SUBJECT: Site Plan Review for Norton Road Trailhead Park for Summit County
Metroparks, PP#3009954

PC Case No: 2016-13

RE: PC 2016-13 Trailhead Park for Metroparks Serving Summit County

SUMMIT METRO PARKS
BIKE AND HIKE TRAILHEAD
IMPROVEMENT PLANS

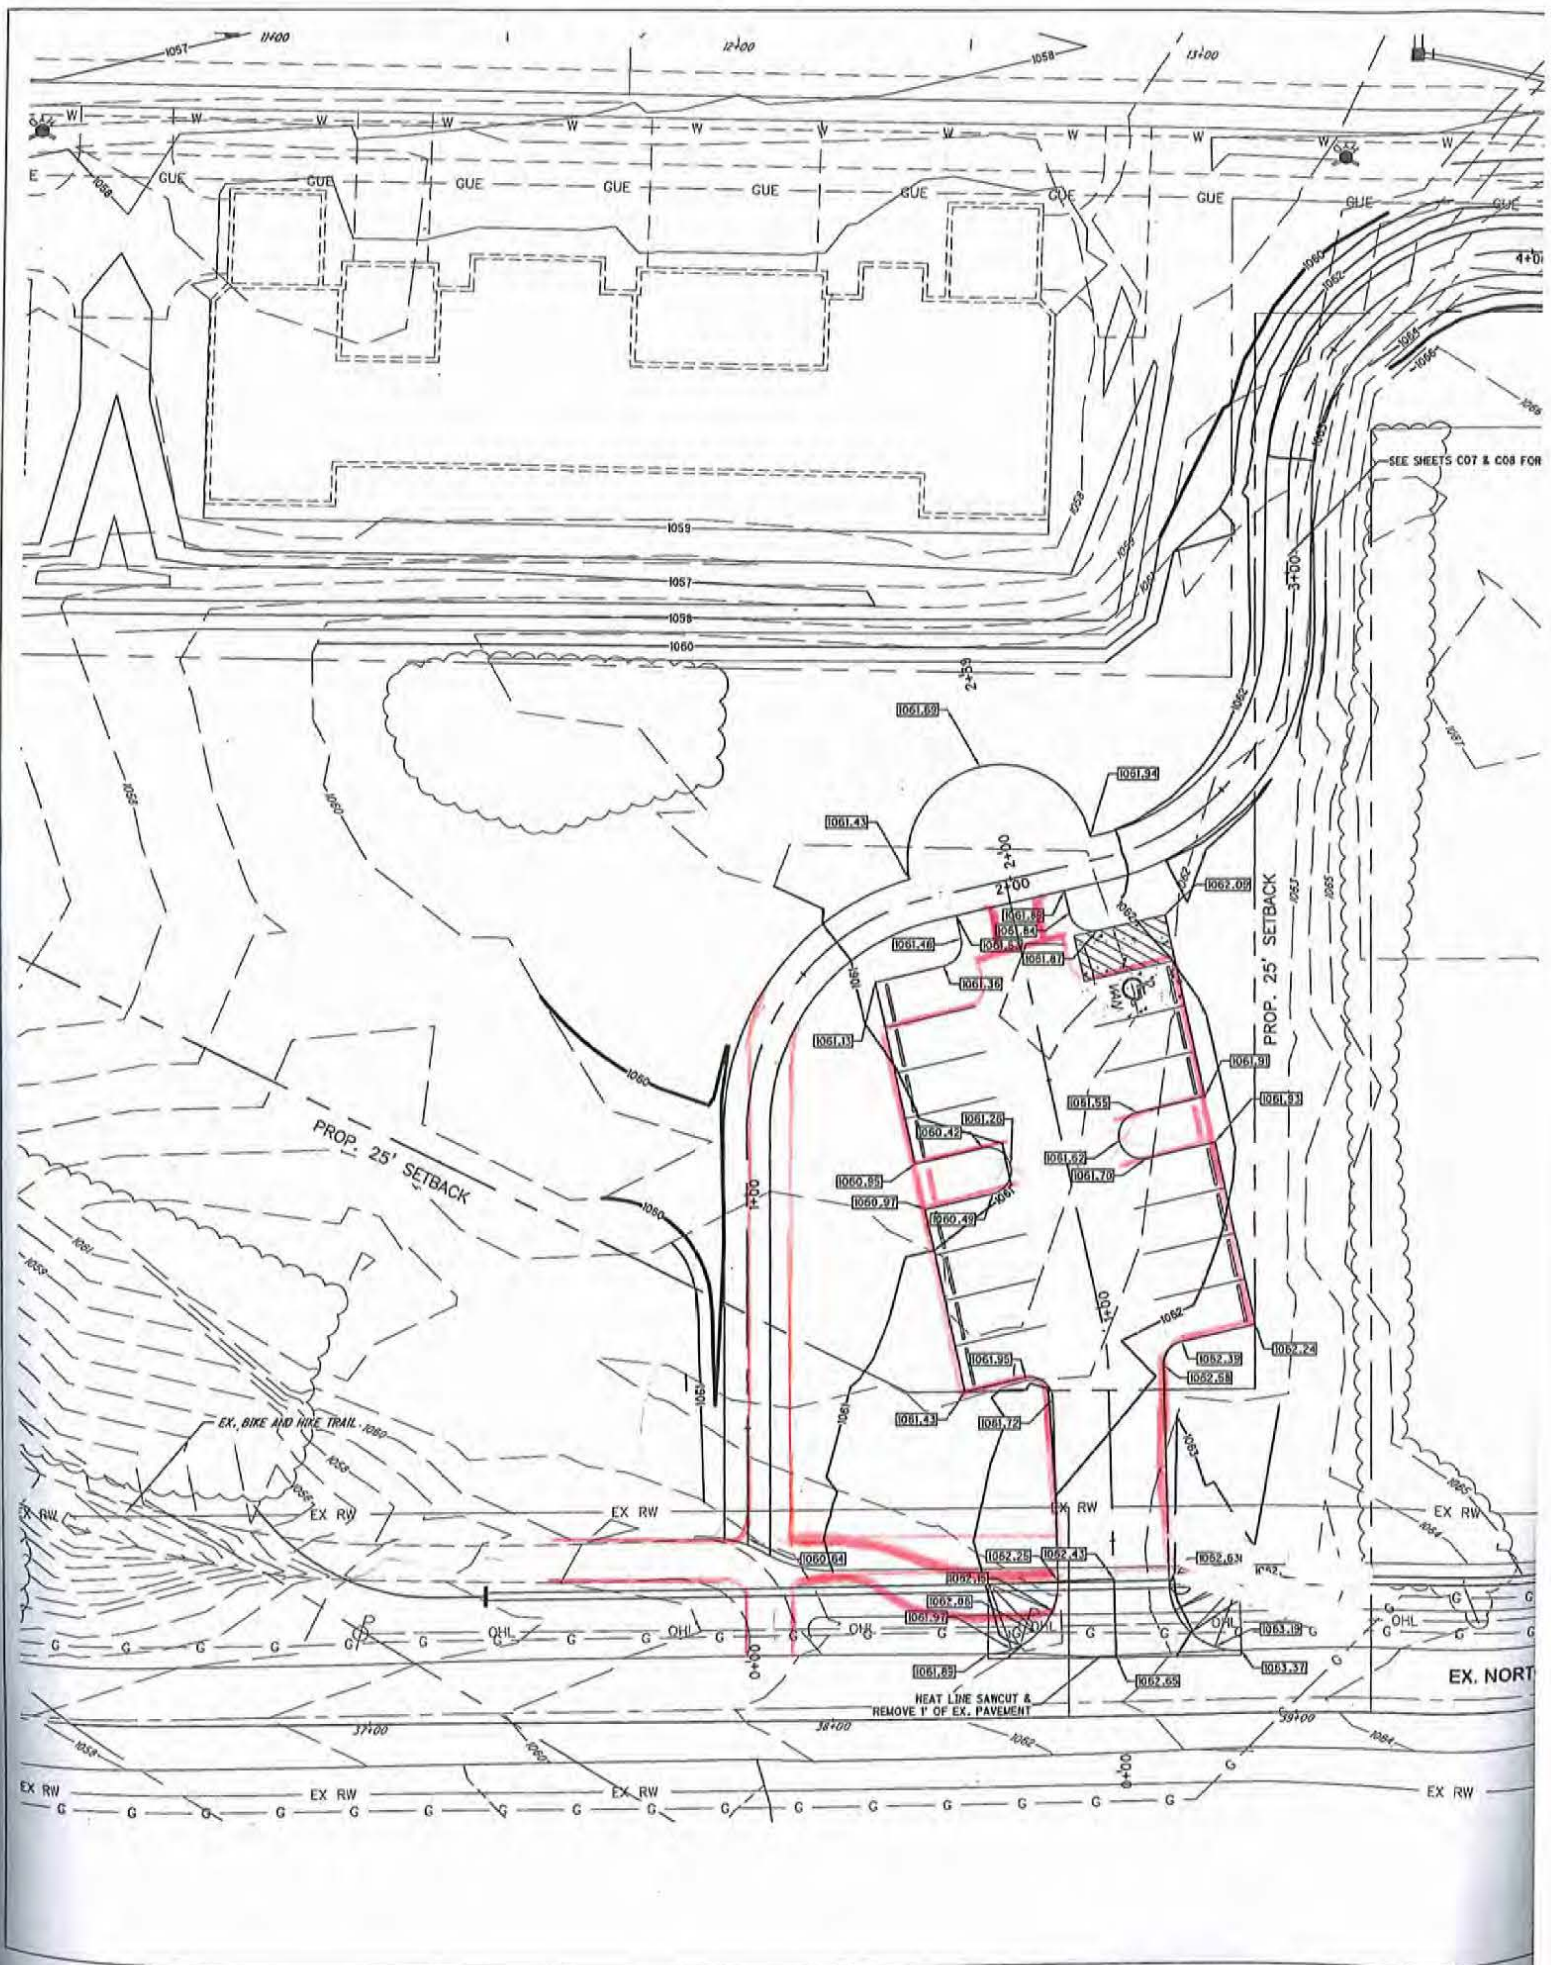
- a) Stall dimensions: The parking stall depth can be reduced to 19 feet.
- b) Maneuverability area: The northern end of the parking area contains a back up area abutting the trail. This connection should be revised to create a lawn/landscaped area between the two with only a 10 foot wide path connection and a bollard to restrict vehicle access (see attached).
